The second set of draft Plan text was initially distributed March 9, 2020. Edits to the second set are shown as underline and text proposed for deletion is shown with a ~~strikethrough~~.

Draft revisions incorporating individual Task Force and community group comments

For discussion at the June 29, 2020 Task Force meeting

Figure XX [Old Dominion Drive (Avenue Type 1) cross-section graphic] for Old Dominion Drive between Dolley Madison Chain Bridge Road

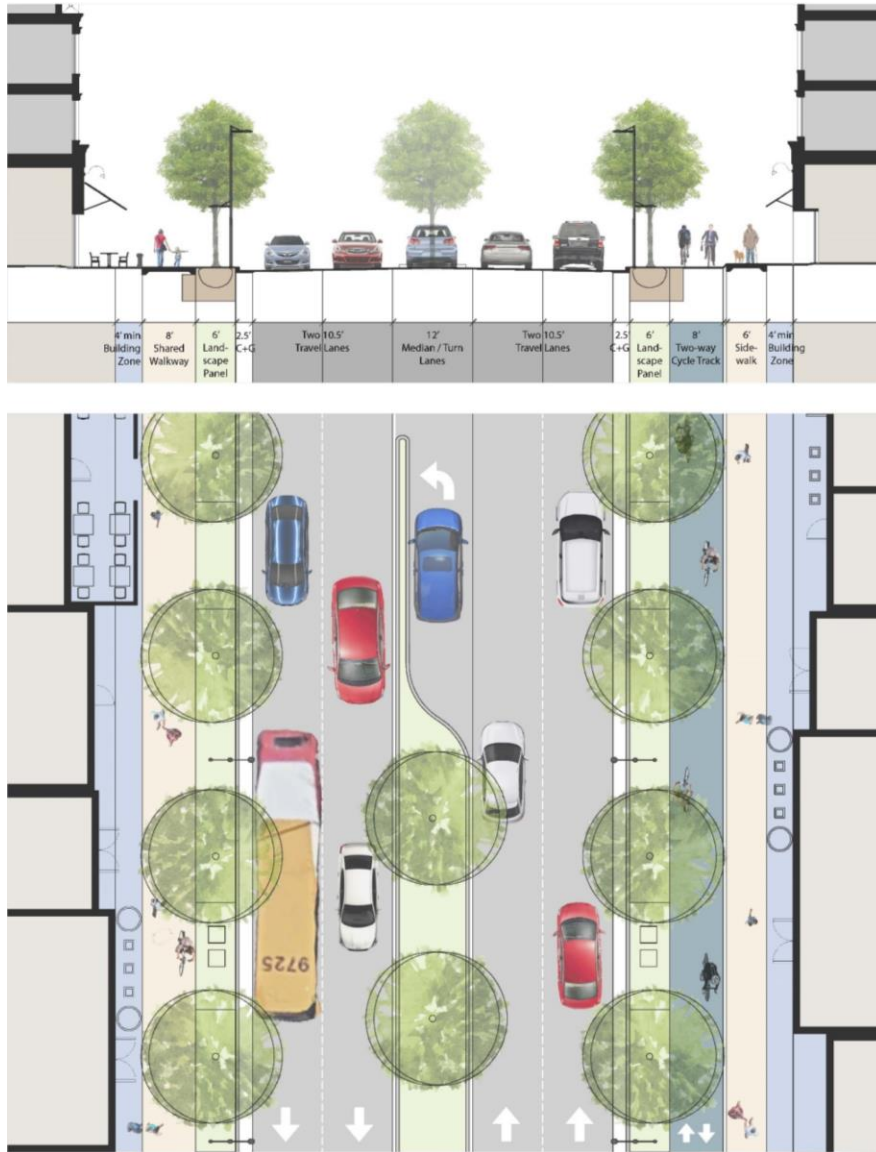
Pedestrian and bicyclist facilities and dimensions for Old Dominion Drive between Chain Bridge Road and the southeastern boundary of the CBC (Arterial):

- Shared Use Path on ~~one~~ the north side of the road.
- 8-foot shared walkway on ~~one~~ the south side of the road.

Figure XX Old Dominion Drive (Avenue Type 1) cross-section graphic]

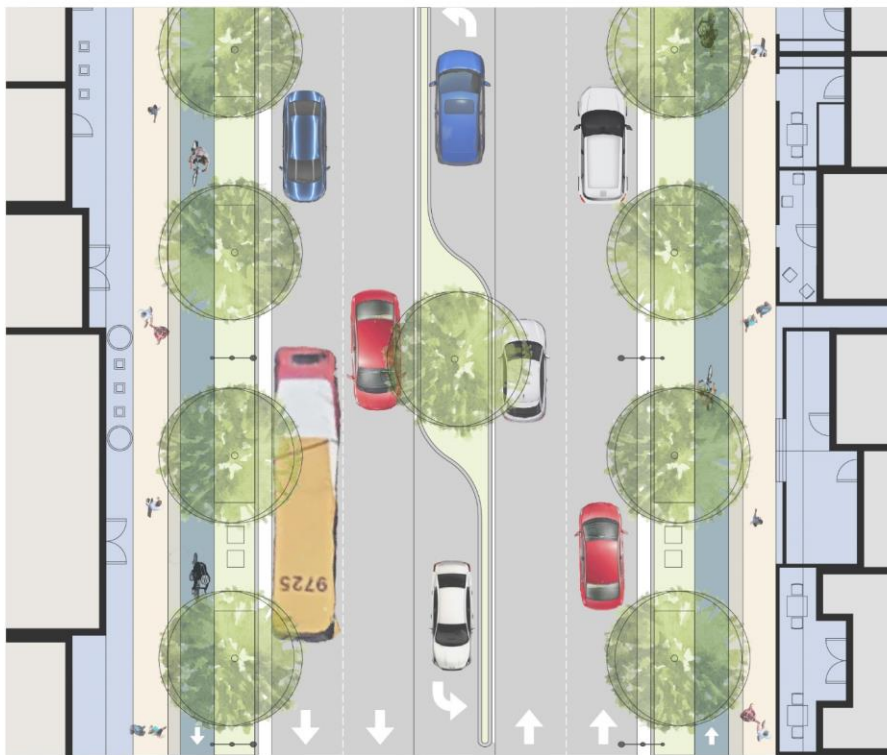
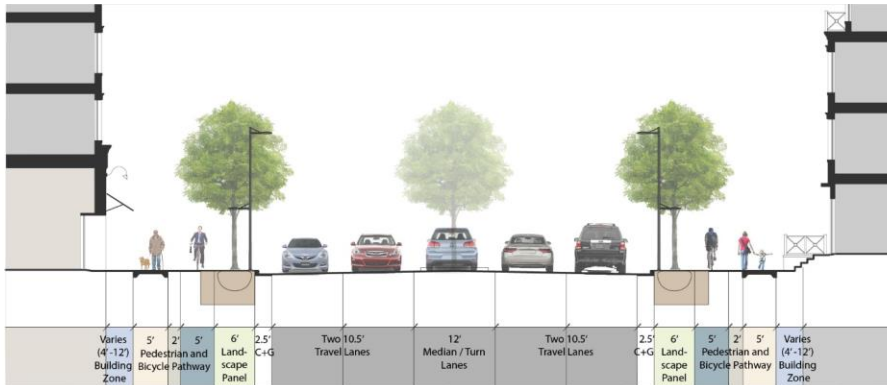
Pedestrian and bicyclist facilities and dimensions for Old Dominion Drive between Holmes
Place and the southeastern boundary of the CBC (Arterial):

- 8-10-foot Shared Use Path on both sides of the road.

Figure XX Chain Bridge Road (Avenue Type 2) cross-section graphic]

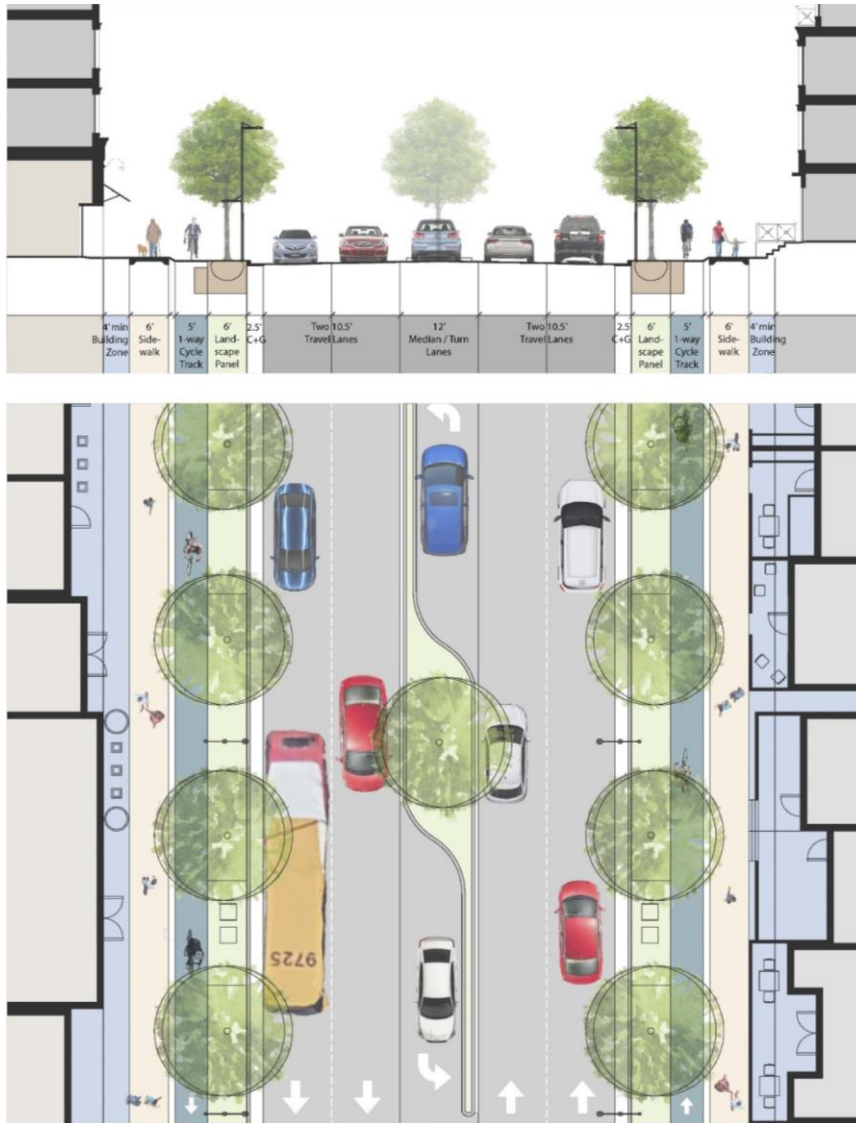
~~Conceptual~~ Pedestrian and bicycle elements and dimensions for Chain Bridge Road from
Ingleside Avenue/Tennyson Drive to Davidson Road:

- 8-10-foot Shared Use Path on both sides of the road.

660 *Figure XX: Other streets and new streets (Local Streets Type 2) cross section*

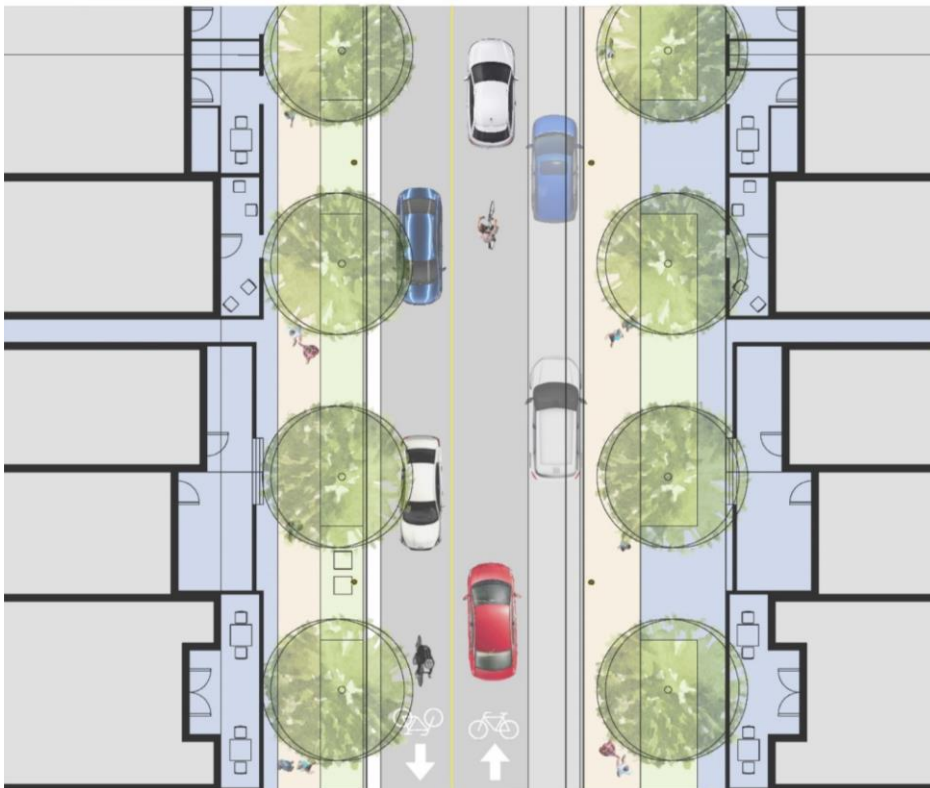
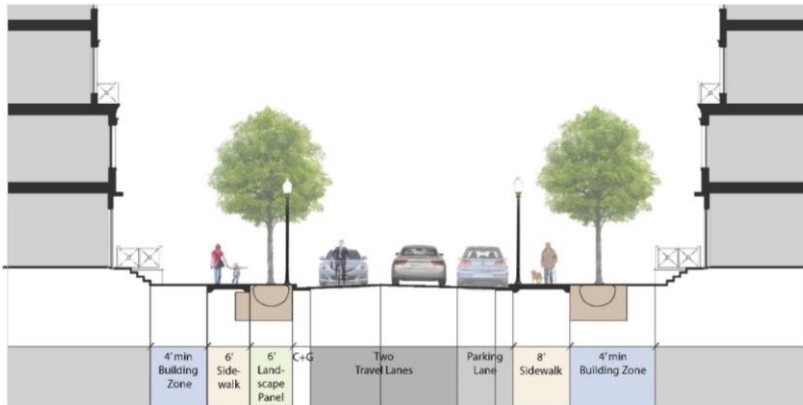
- Building Zone – See building zone guidance under Cross-sections and Streetscape Design. ~~When ground level commercial use is provided in a building, the building zone should provide a 4 foot minimum. Multifamily residential uses should provide a 4 foot minimum and may have stoops, porches and/or stairs within this zone. Supplemental plantings (to include shade and flowering trees, shrubs, flowering plants, ground cover, and grasses) may also be located in the building zone.~~ Where street trees cannot be accommodated within the right-of-way, they should be provided within the building zone. Single family residential uses should use the Zoning Ordinance setback rather than providing a building zone.
